## SERVICE BULLETIN

ENGINE - LP COMPRESSOR - TO REVISE MODULE ASSEMBLY NUMBER ON THE IDENTIFICATION PLATE  
- CATEGORY CODE 6 - MOD.ENG-72-0213

V2500-ENG-72-0213

Reidentification of the new module identification plate  
Fig.1

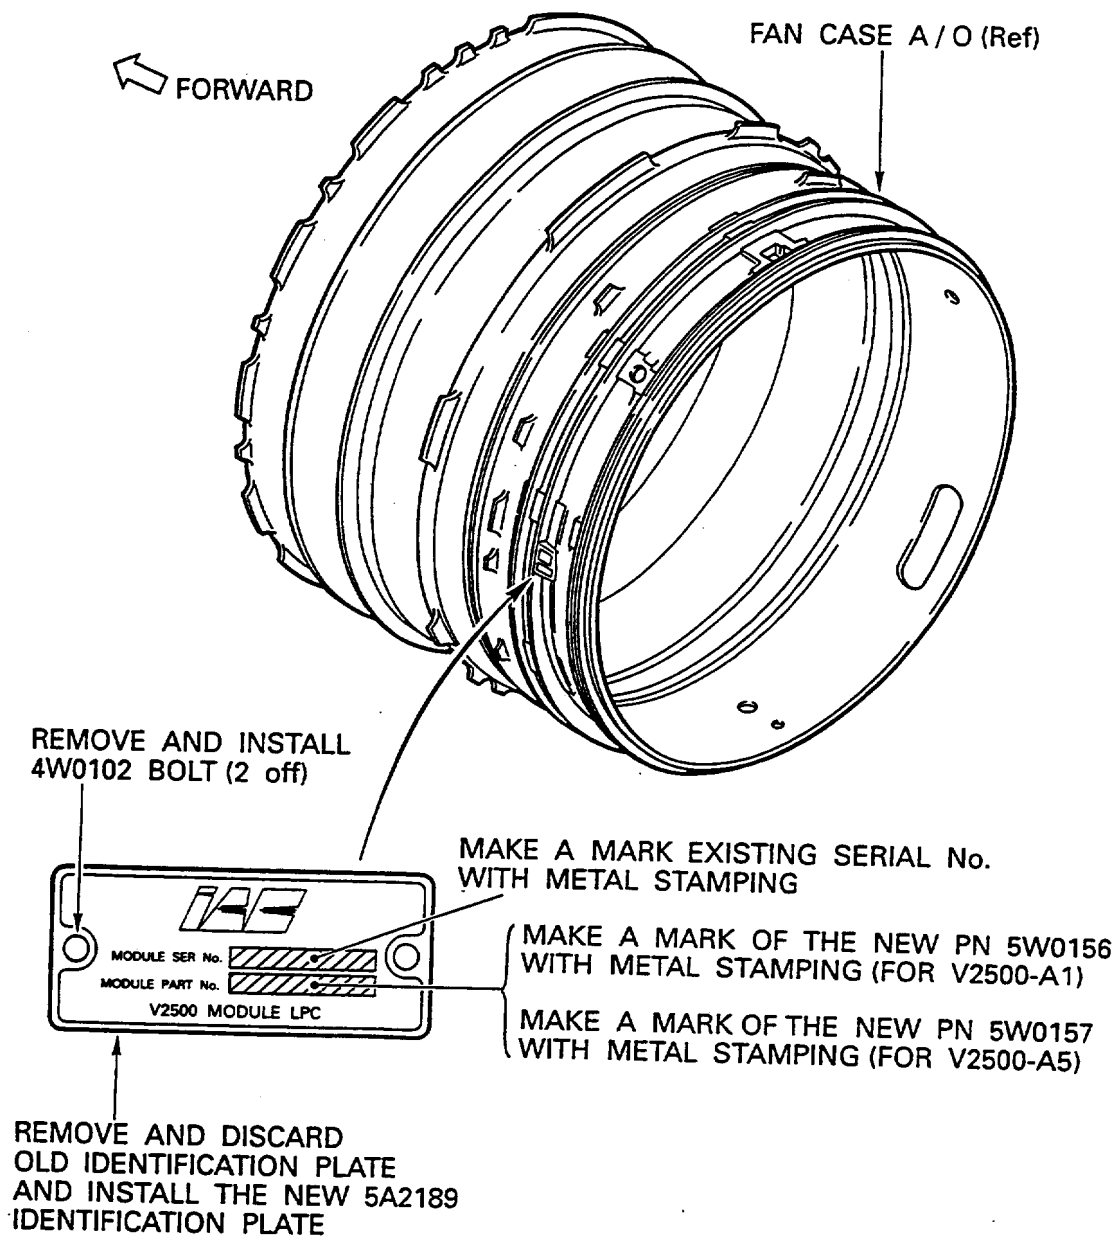
(b) Change the existing module assembly number 5W0153 with the new number 5W0156 and approved procedures as follows (Refer to Figure 1):

- 1 Remove the existing two 4W0102, bolts from the module identification plate on the fan case.
- 2 Remove the existing module identification plate and discard it.

- 3 Make a mark of the new module part number 5W0156 and existing serial number to the new 5A2189, module identification plate by the approved procedures in Reference (1), Chapter/Section 70-09-00, Marking of Parts.
- 4 Install the marked new module identification plate with the two 4W0102, bolts in to sufficient position.
- 5 Torque the bolts to 36 to 45 lbfin (4,00 to 5,00 Nm) with CoMat 10-077 approved engine oil.

(b) Change the existing module part number 5W0150 with the new number 5W0157 and approved procedures as follows (Refer to Figure 1):

- 1 Remove the existing two 4W0102, bolts from the module identification plate on the fan case.
- 2 Remove the existing module identification plate and discard it.

NOTE: Make sure the existing serial number on module identification plate before you discard it.
- 3 Make a mark of the new module part number 5W0157 and existing serial number to the new 5A2189, module identification plate by the approved procedures in Reference (1), Chapter/Section 70-09-00, Marking of Parts.
- 4 Install the marked new module identification plate with the two 4W0102, bolts in to sufficient position.
- 5 Torque the bolts to 36 to 45 lbfin (4,00 to 5,00 Nm) with CoMat 10-077 approved engine oil.
